**TO:** Tasha Bolivar, Galloway and Company  
**FROM:** Amber Wood Hicken, Planner I  
**DATE:** 2/6/23  
**SUBJECT:** Parker and Pine F1 L1 – In-n-Out Burger, Site Plan  
Review Comments 01

Staff Comments 01  
SP22-143; Parker and Pine  
In-n-Out; Site plan  
2/6/23

IN-N-OUT BURGER  
SITE PLAN  
PARKER & PINE FILING NO. 1, LOT 1

**LANDSCAPE PLAN**

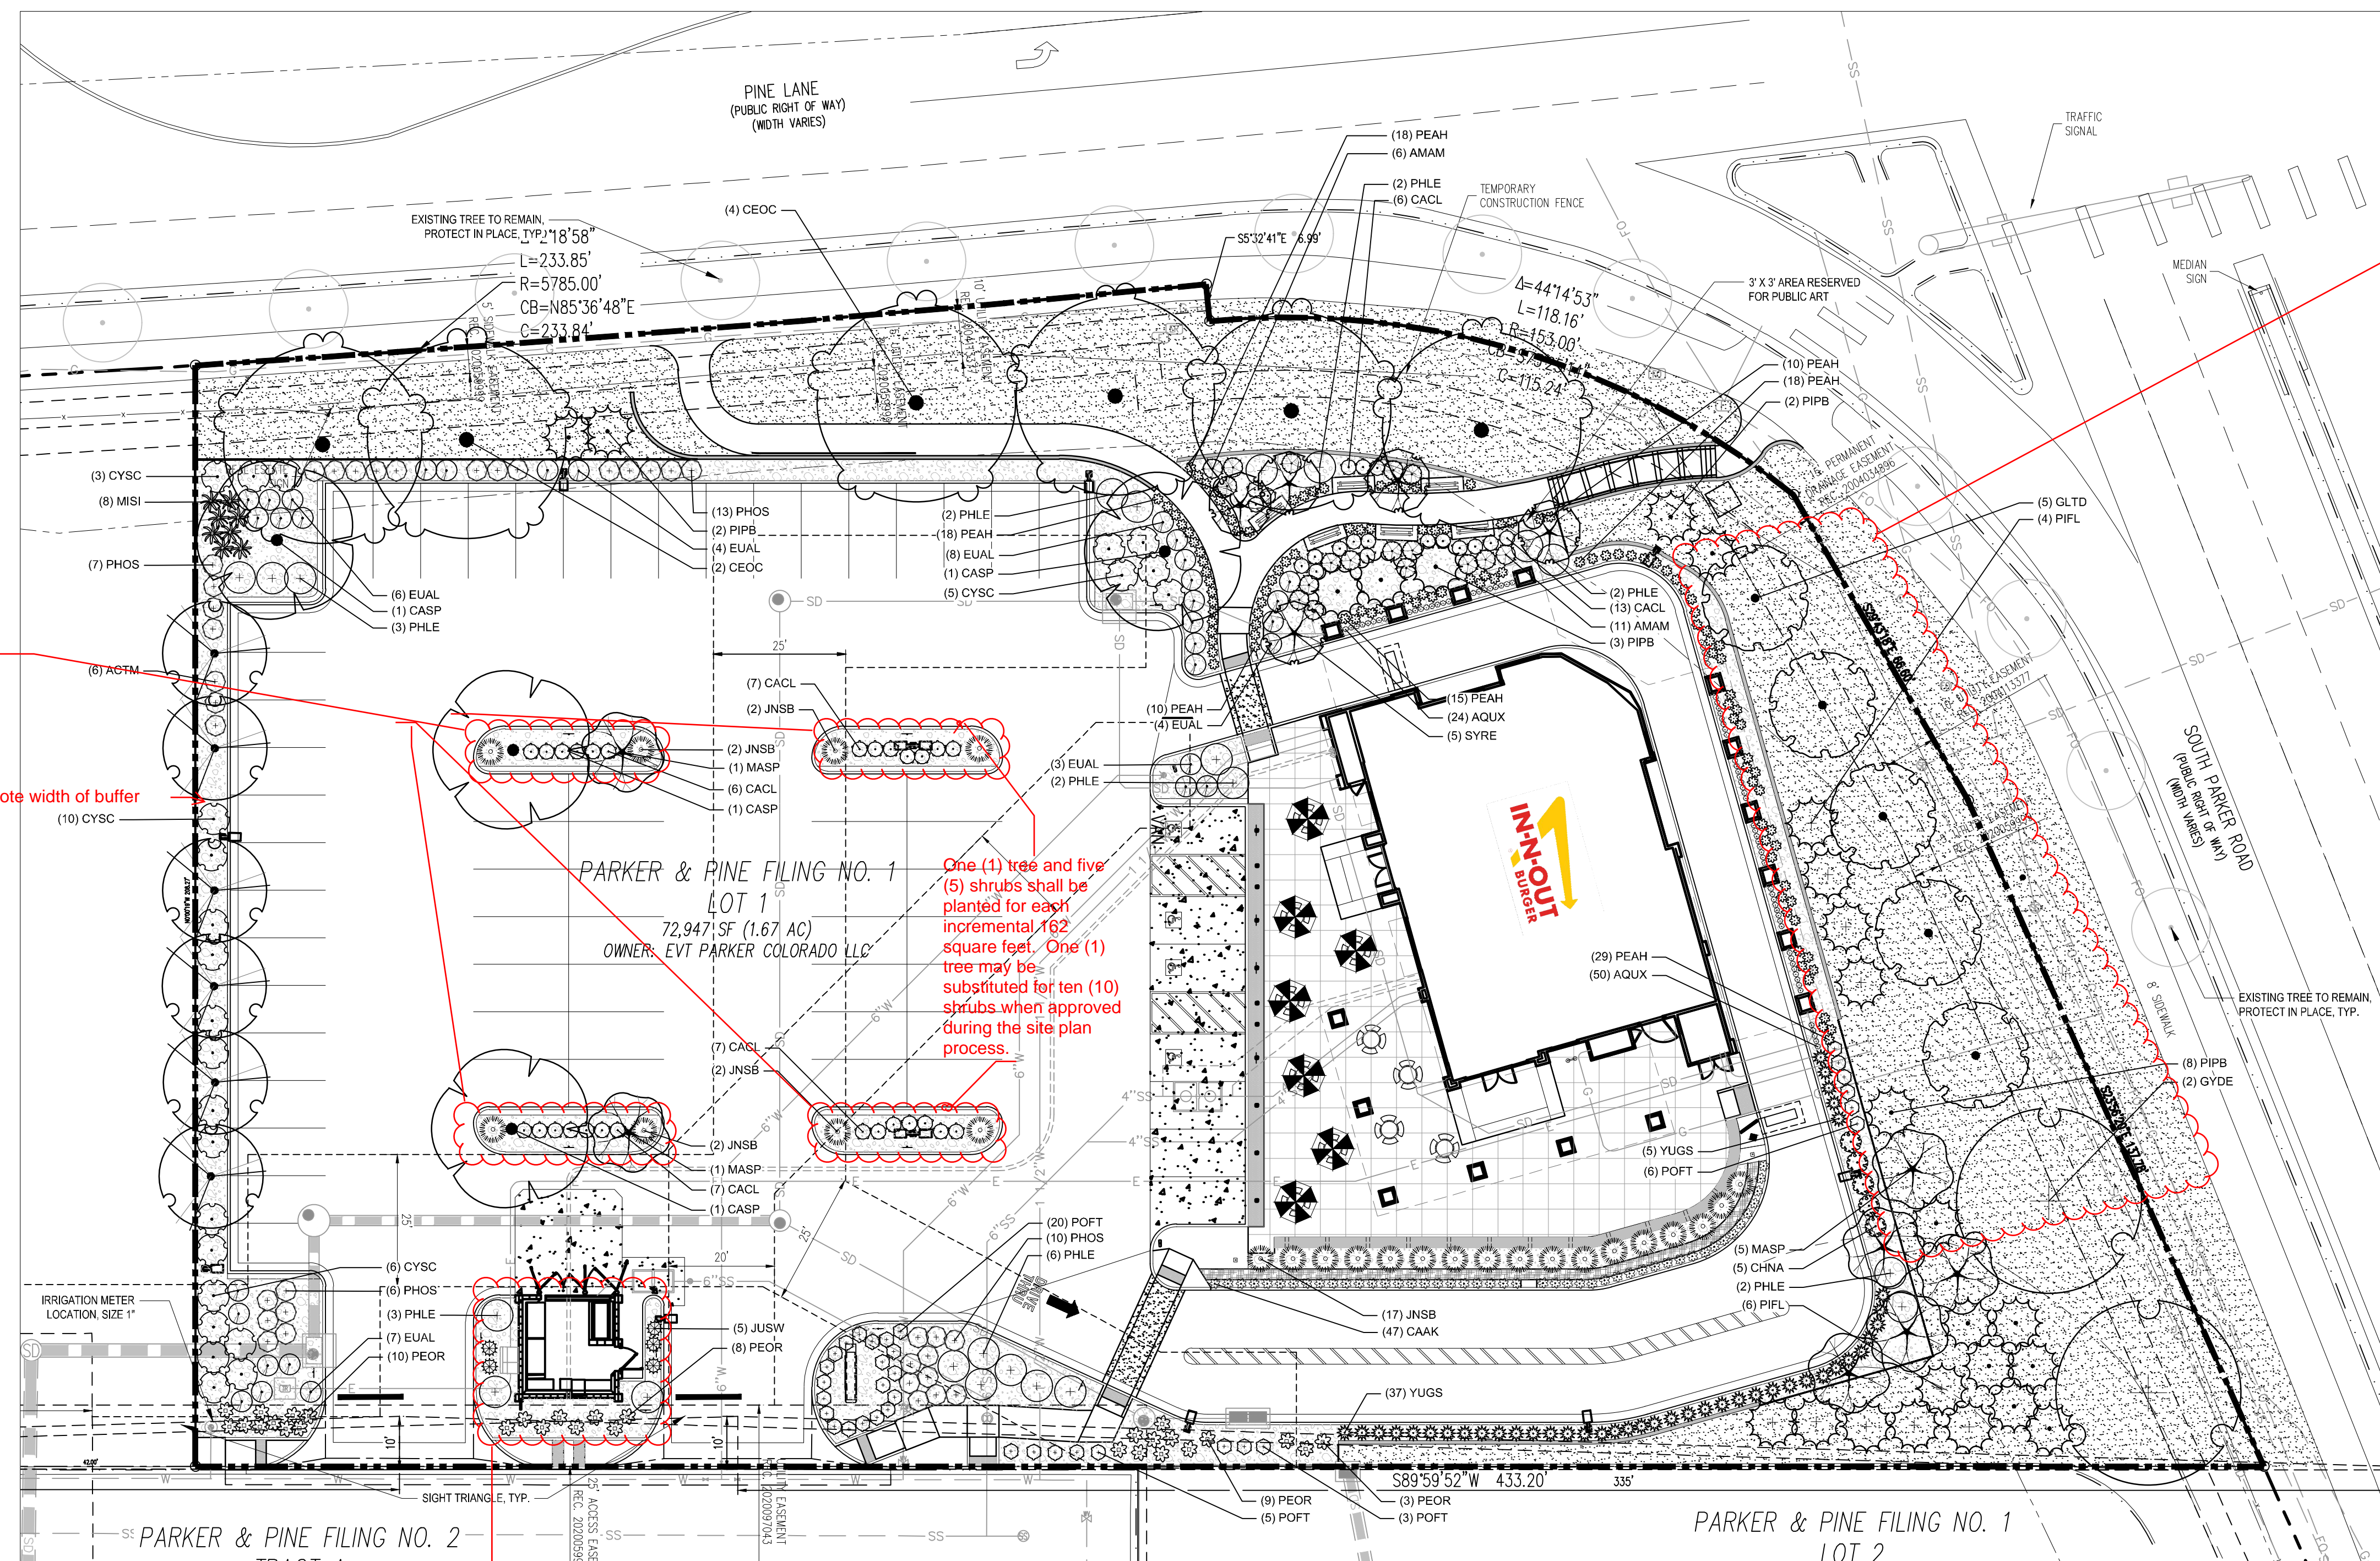
Please enhance screening - Where drive-through windows and facilities cannot be designed to avoid adjacency to public roadways, they shall be covered with a canopy that is integrated into the design of the building and screened with landscaping with an opacity of 80% at one (1) year maturity, a maximum of three (3) feet in height, or screened by a decorative solid wall with a maximum of four (4) feet in height. Design Standards pg 25

Provide width. Landscaped islands shall be at least the size of one (1) full-sized parking space (one hundred sixty-two [162] square feet) and have no dimension fewer than nine (9) feet.

Note width of buffer

One (1) tree and five (5) shrubs shall be planted for each incremental 162 square feet. One (1) tree may be substituted for ten (10) shrubs when approved during the site plan process.

Enhance landscaping to screen trash enclosure

\*at least\*

east side of property requires parking lot perimeter landscaping

Parking lots adjacent to similar uses shall provide for a buffer a minimum width of eight (8) feet from the property line or lease line. 13.06.070

Parking lot interior landscaping does not apply to commercial developments requiring less than 80 spaces

Please provide evergreen percentage (40%-60% min/max for site perimeter)

Please add a note that these trees are existing

Remove all signature blocks.

**SOUTH ELEVATION**

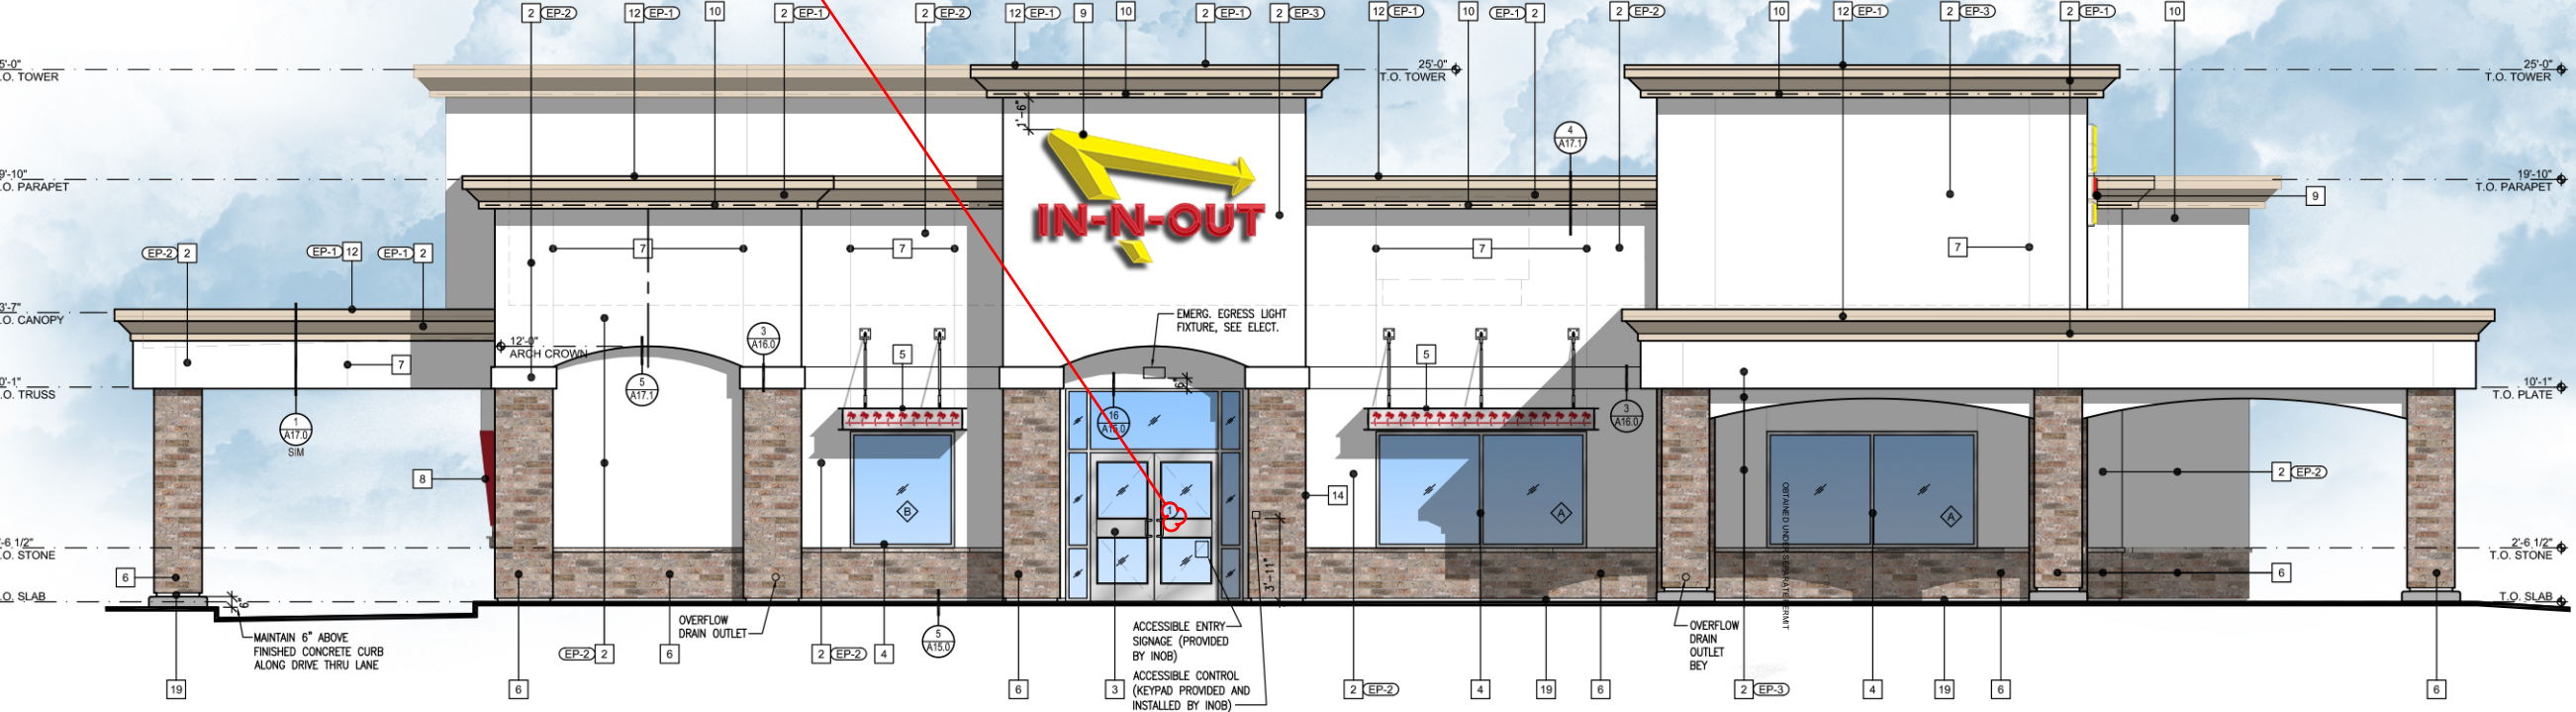
What is this callout?

Please callout type of glass

**WEST ELEVATION**

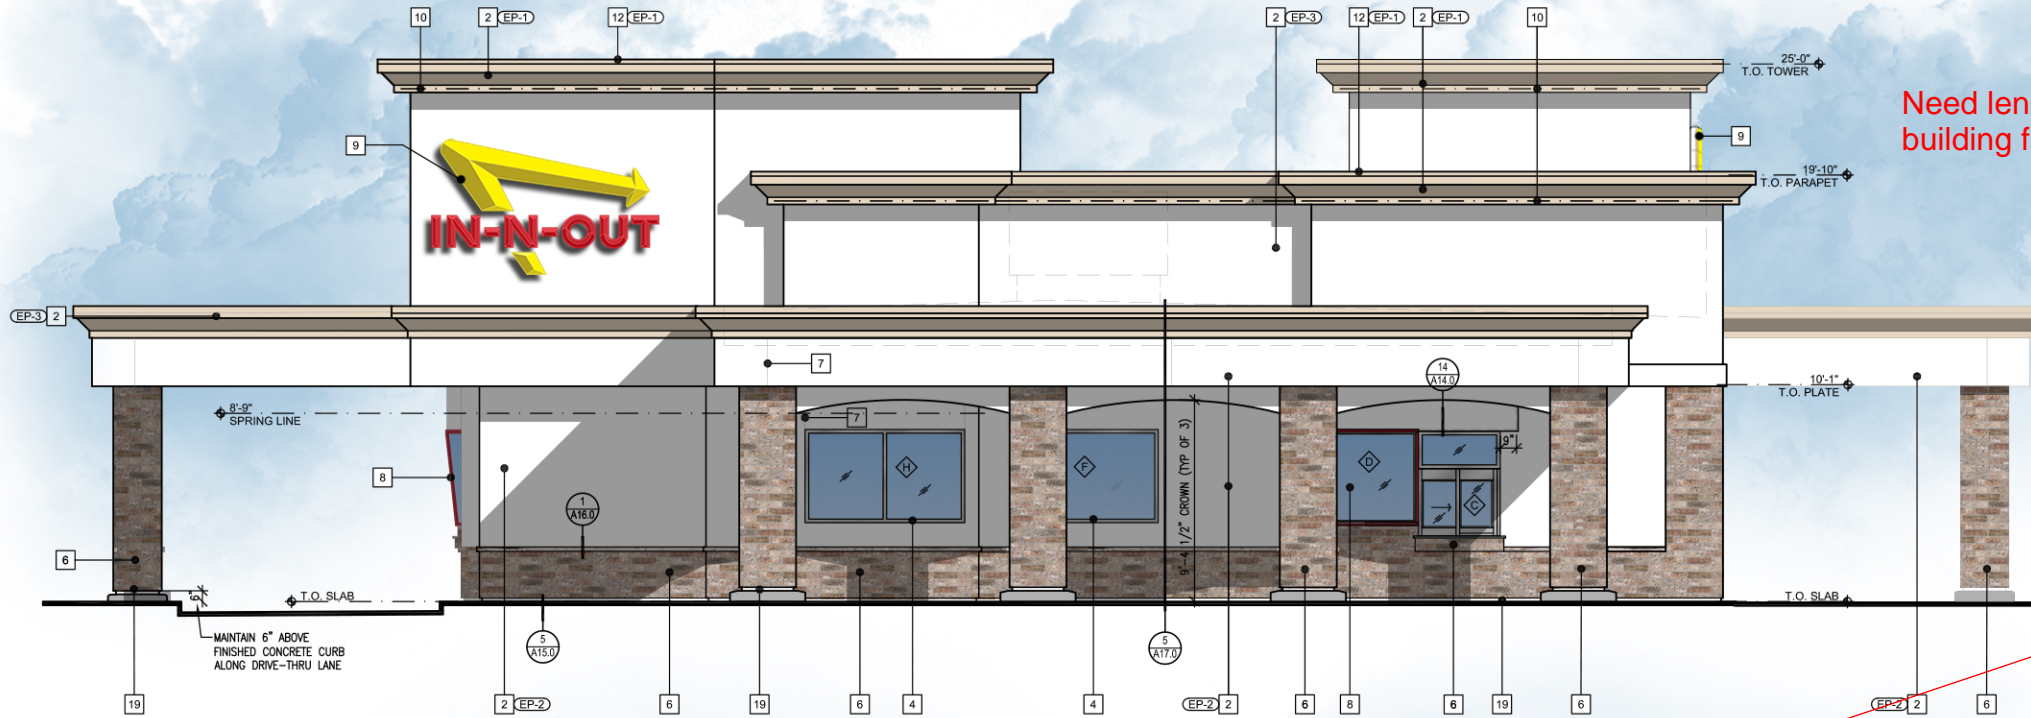
Please provide vertical massing info (i.e., how far does canopy come out?)

**NORTH ELEVATION**

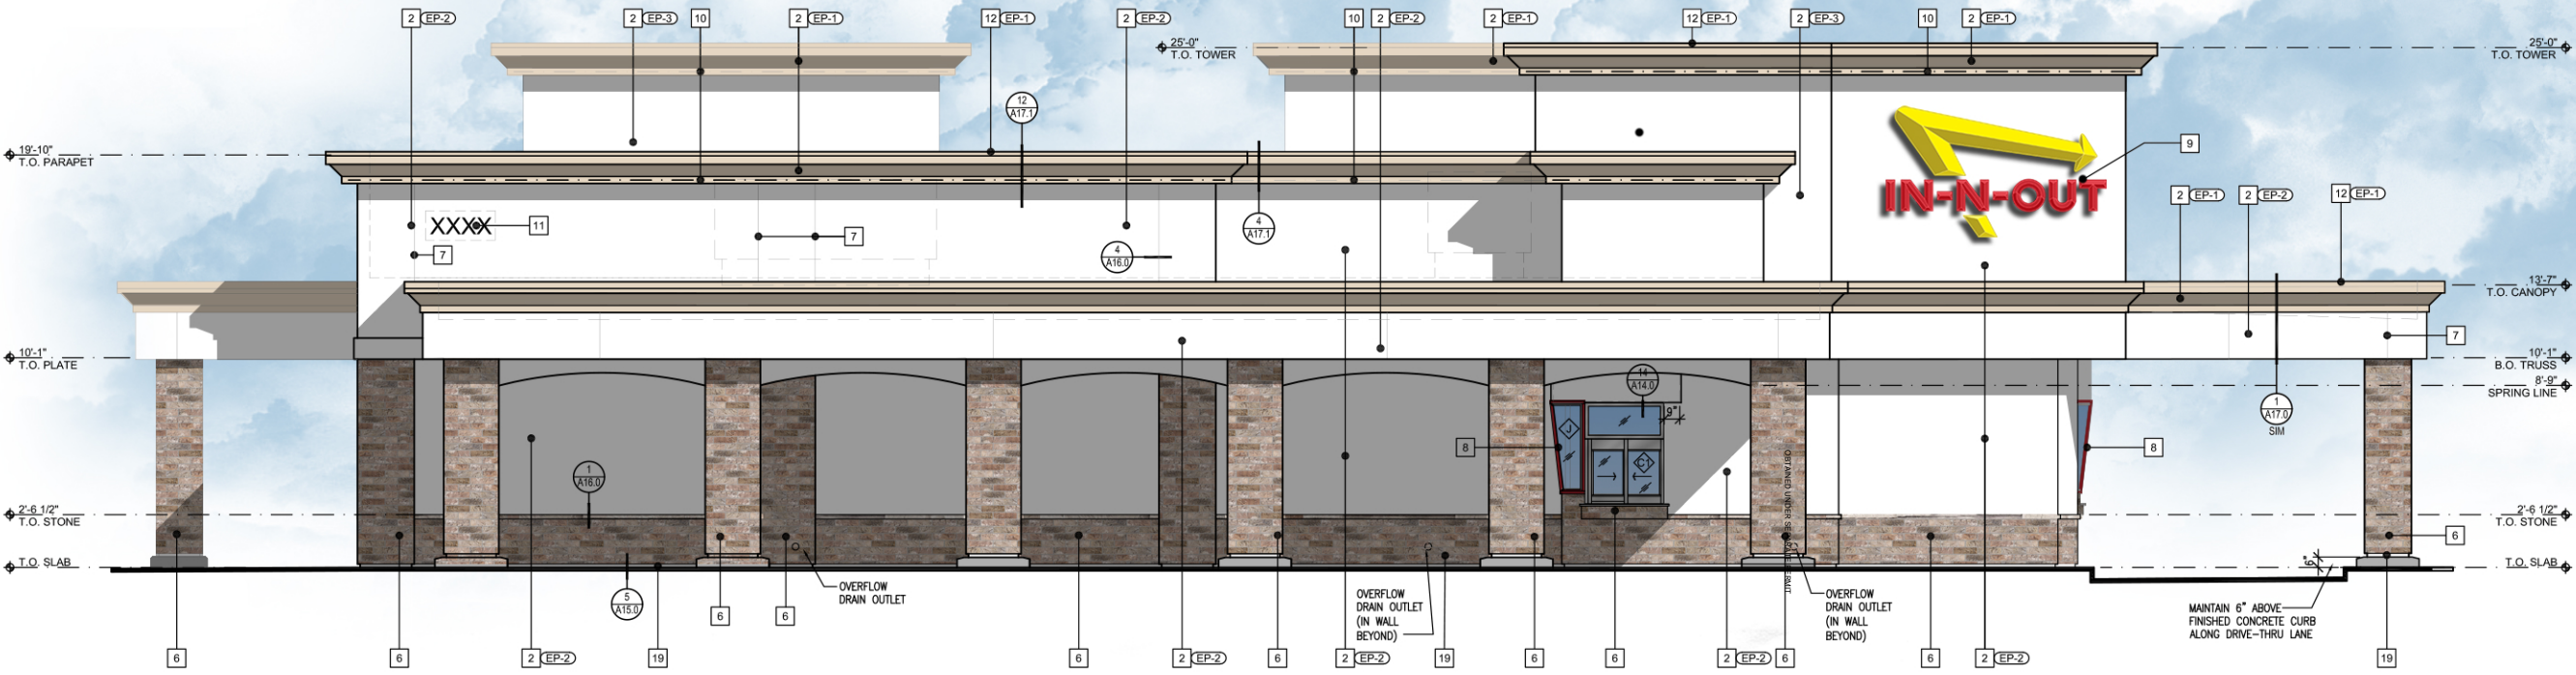
Need length of building facade

Need transparency percentages for all building sides.  
 North (side): 25%  
 East (front): 40%  
 South (front): 40%  
 West (front): 40%

Building front: The side of the building facing the most prominent public roadway or internal street or open space; the facade on which the primary building entrance is located. Design Standards pg 9
